PRM-50-93 & 50-95
(75FR66007)

**Comments on
Nuclear Regulatory Commission's Draft Interim Reviews of
Two Petitions for Rulemaking: PRM-50-93 and PRM-50-95; NRC-2009-0554**

Submitted by
Mark Edward Leyse
P.O. Box 1314
New York, NY 10025
markleyse@gmail.com

Figure 1. Local Cladding Temperature vs. Time in the PHEBUS B9R-2 Test³⁴

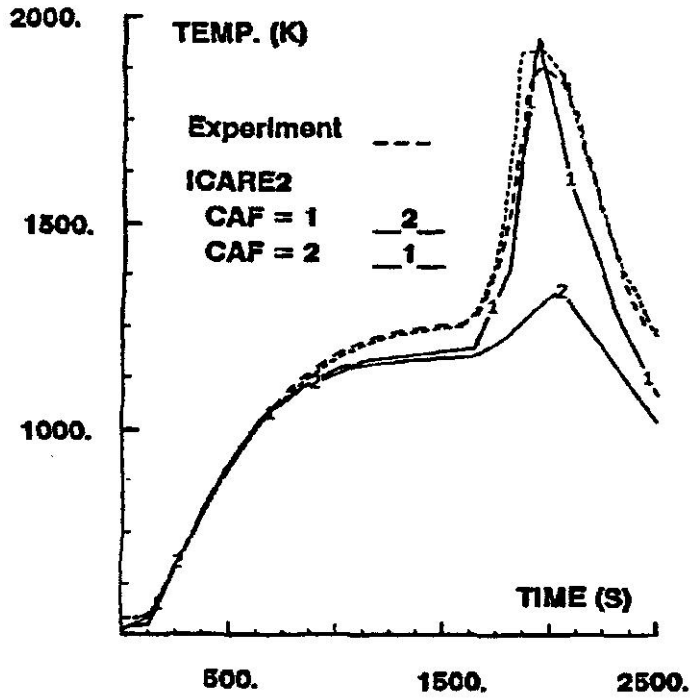
approximately 877°C (1610°F) and 1002°C (1835°F).³³ (See Figure 1.) As stated, the cladding-temperature escalation commenced at approximately 1027°C (1880°F).

**Appendix B Photographs of the Section of the Test Bundle from FLECHT Run
9573 that Incurred Runaway Oxidation**

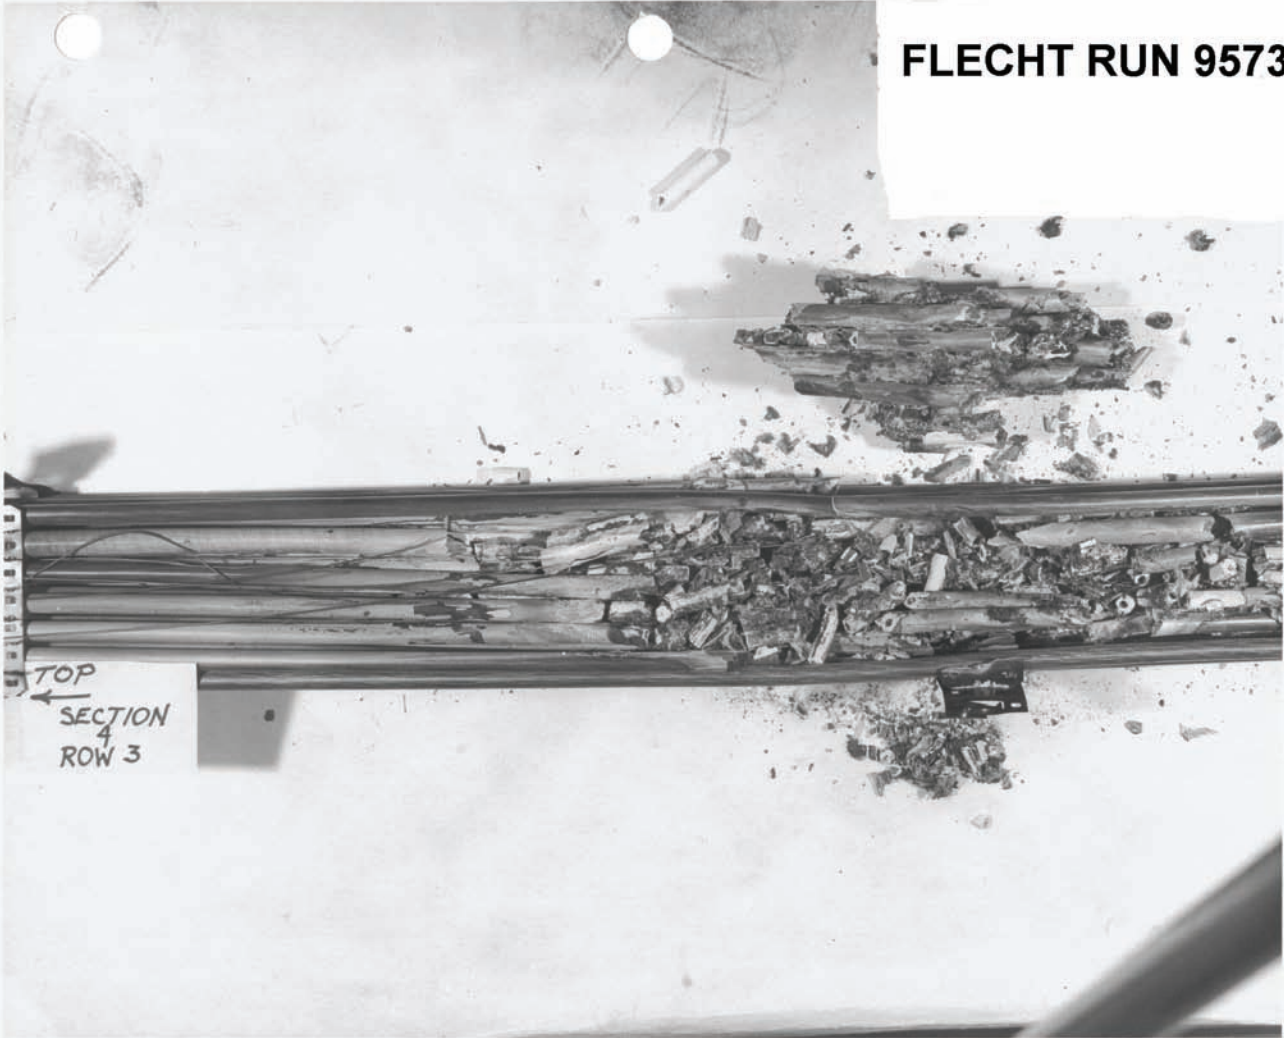
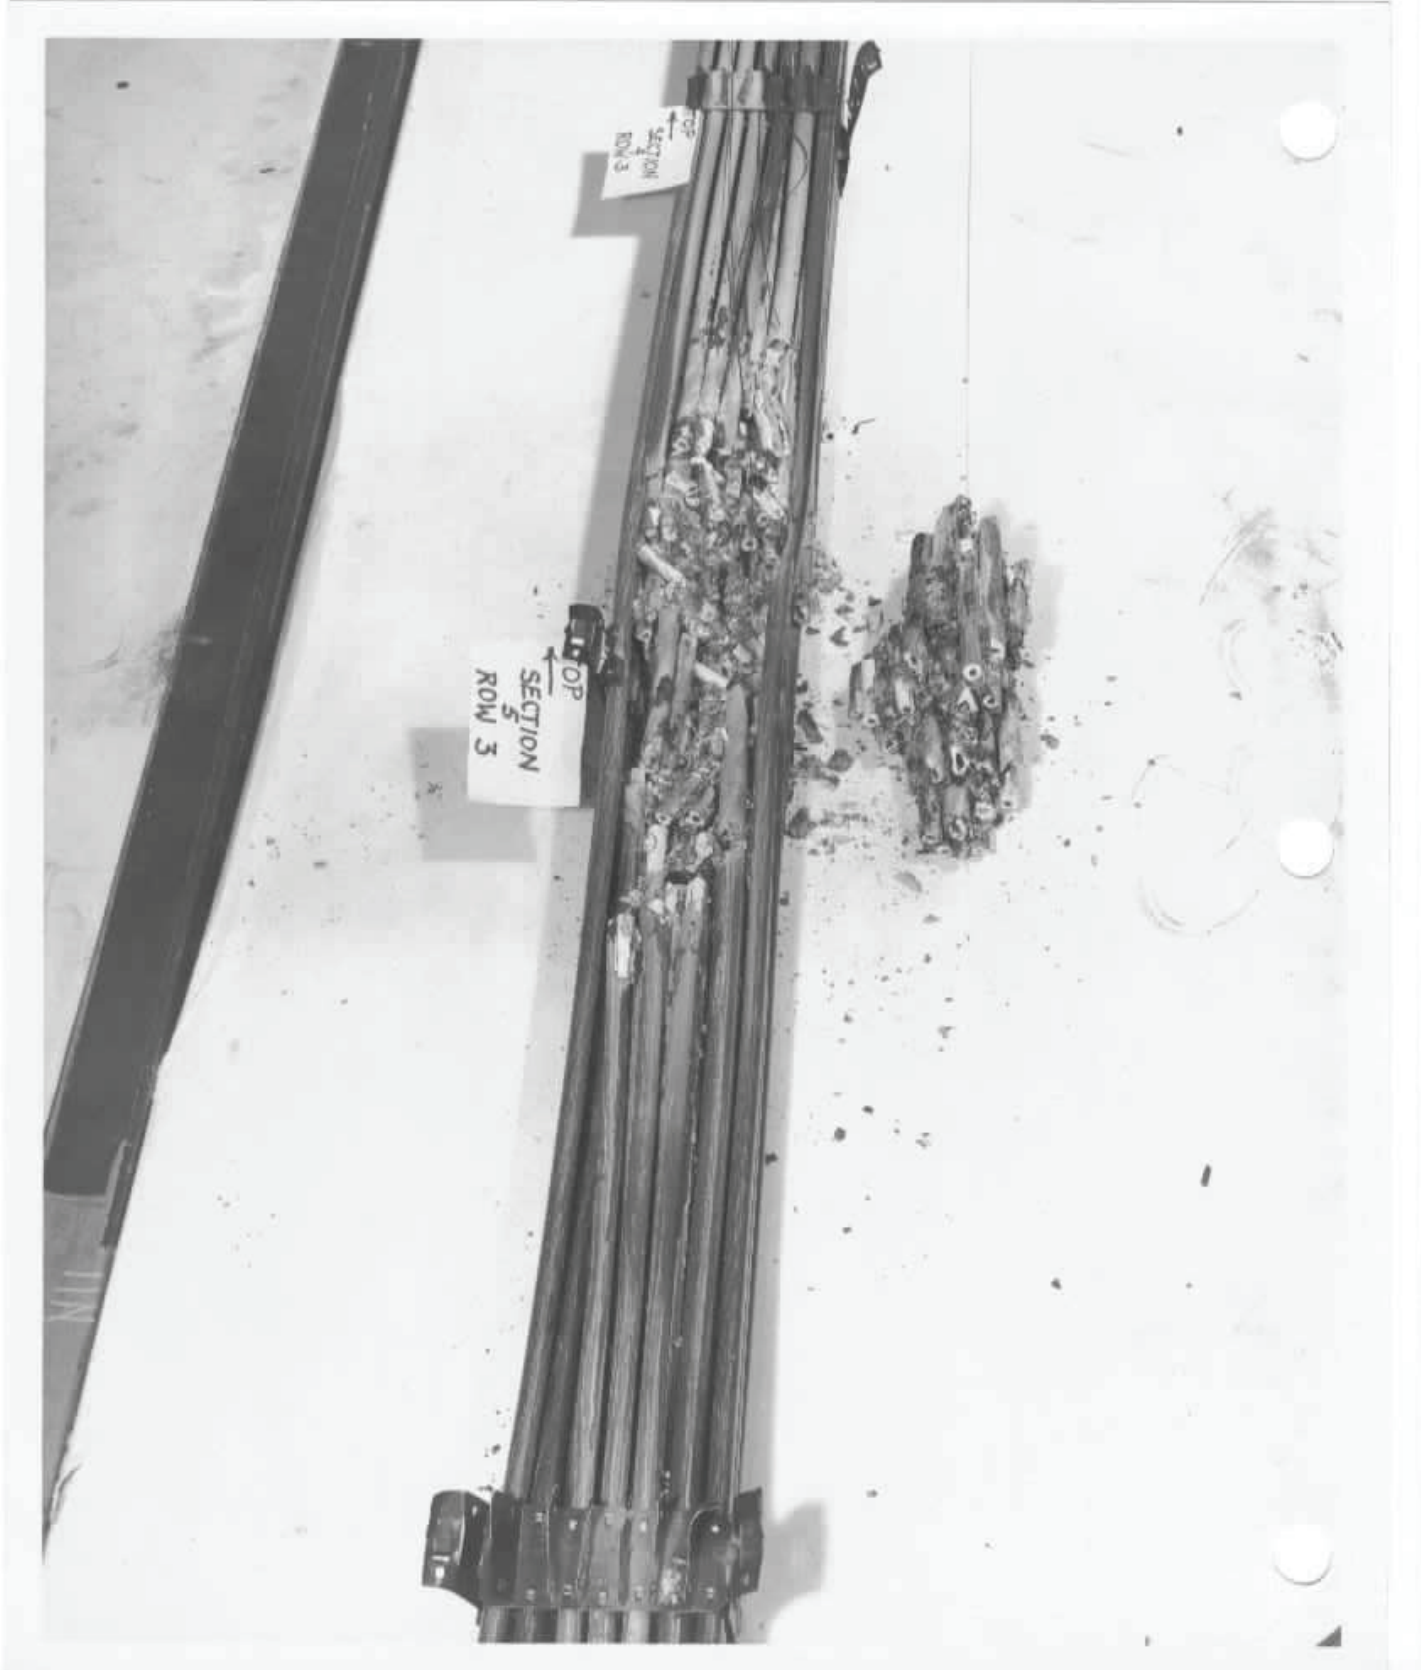
Unfortunately, in FLECHT run 9573 there were no thermocouples located at the section of the test bundle which incurred runaway oxidation—around the 7 ft elevation. (There was a steam probe thermocouple located at the 7-foot elevation.⁴³) Hence, NRC's TRACE simulations of FLECHT run 9573 did not include the section of the test bundle that incurred runaway oxidation.

As already stated in PRM-50-93 (pages 59, 60), Westinghouse reported, regarding the FLECHT run 9573 bundle, that a “[p]ost-test bundle inspection indicated a locally severe damage zone within approximately ± 8 inches of a Zircaloy grid at the 7 ft elevation.”⁴⁴ (See Figure 1.) And, as previously stated in PRM-50-93 (page 60), Westinghouse reported that “[t]he remainder of the [FLECHT run 9573] bundle was in

Therefore, NRC’s TRACE simulations of FLECHT run 9573, using the Baker-Just and Cathcart-Pawel correlations, encompassed locations—the 2, 4, 6, 8, and 10-foot elevations of the test bundle—that most likely were steam starved or partly steam starved (hydrogen produced by the zirconium-steam reaction would have also diluted the available steam). Petitioner contends on the basis of this evidence that NRC’s TRACE

As already stated in PRM-50-93 (pages 66-67), Westinghouse reported, regarding the FLECHT run 9573 test bundle that “[t]he steam probe thermocouple located one foot above midplane [at the 7-foot elevation] in close proximity to a Zircaloy grid indicated an extremely rapid rate of temperature rise (over 300°F/sec) beginning approximately 12 seconds after flooding and reaching 2450°F by 16 seconds after flooding.”⁵³ (Appendix I of PRM-50-93 is a Westinghouse memorandum, dated December 14, 1970, reporting that the steam heatup rate exceeded 300°F/sec, at the 7-foot elevation.)

**Appendix C Photograph of the Section of the Test Bundle from FLECHT Run
8874 that Incurred Runaway Oxidation**

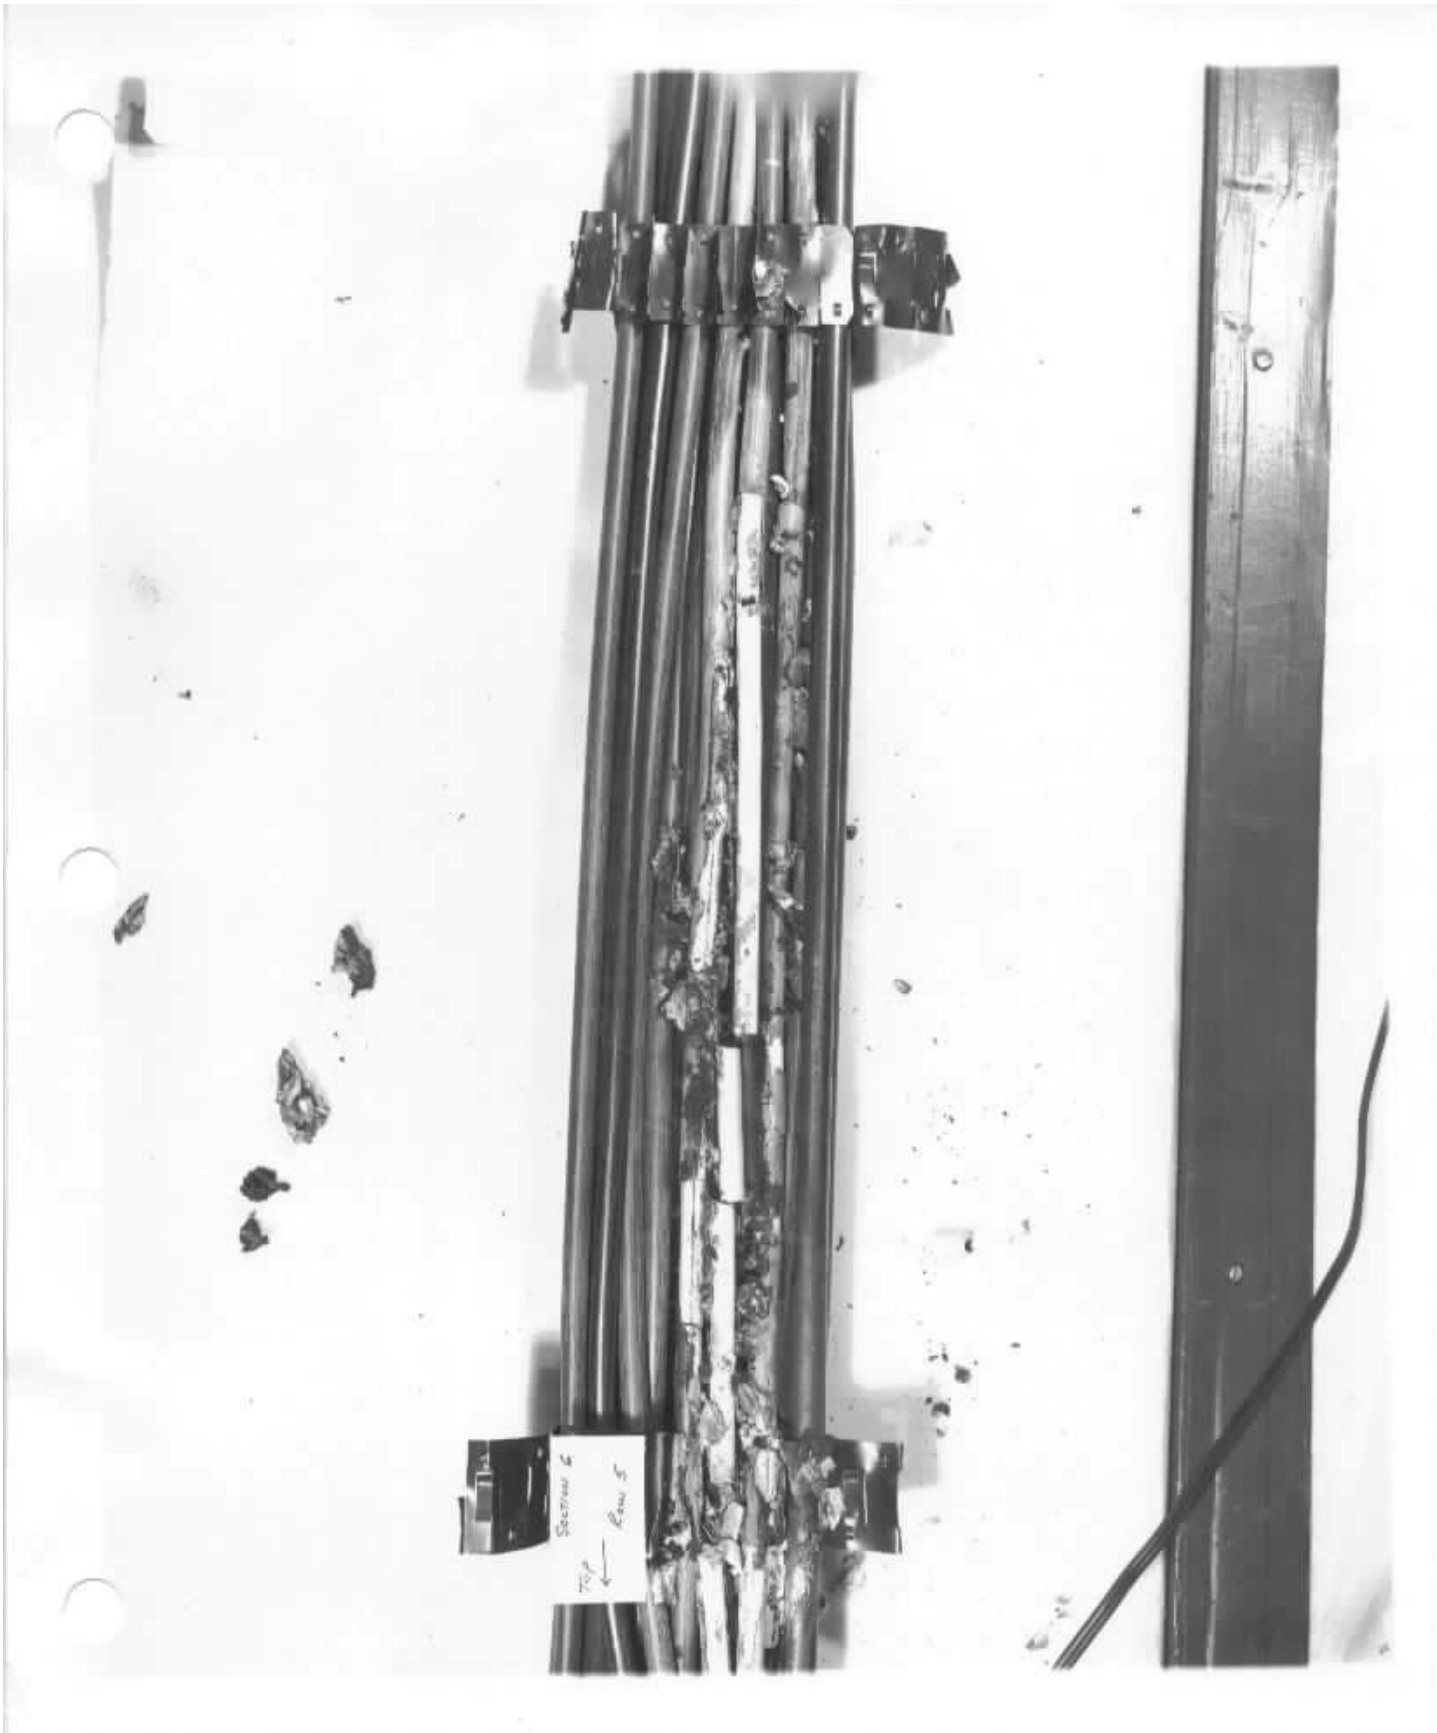
sections that were taken from test rods from Zircaloy PWR FLECHT run 9573, because Westinghouse did not obtain metallurgical data from the locations of the rods from run 9573 that incurred runaway oxidation.³⁶ Then, in comments on PRM-50-93/95, Petitioner stated that Zircaloy PWR FLECHT run 8874 had also incurred runaway oxidation and that Westinghouse did not obtain metallurgical data from the locations of the rods from run 8874 that incurred runaway oxidation. It is probable that the locations of the test bundles from runs 8874 and 9573 that Westinghouse did examine were steam starved: the examined locations had limited oxidation because they had been exposed to a limited amount of steam.

It is reasonable to assume that—as in CORA-2, in which local steam starvation conditions are postulated to have occurred³⁷—in FLECHT runs 8874 and 9573, violent oxidation essentially consumed much of the available steam, so that time-limited and local steam starvation conditions, which cannot be detected in a post-test investigation, would have occurred.

Therefore, Westinghouse's application of the Baker-Just zirconium-steam correlation (used in computer safety models) to the oxide layers on the test bundles from FLECHT runs 8874 and 9573 were to locations that most likely were steam starved or partly steam starved (hydrogen produced by the zirconium-steam reaction would have also diluted the available steam). Clearly, that is not a legitimate verification of the adequacy of the Baker-Just correlation for use in computer safety models.
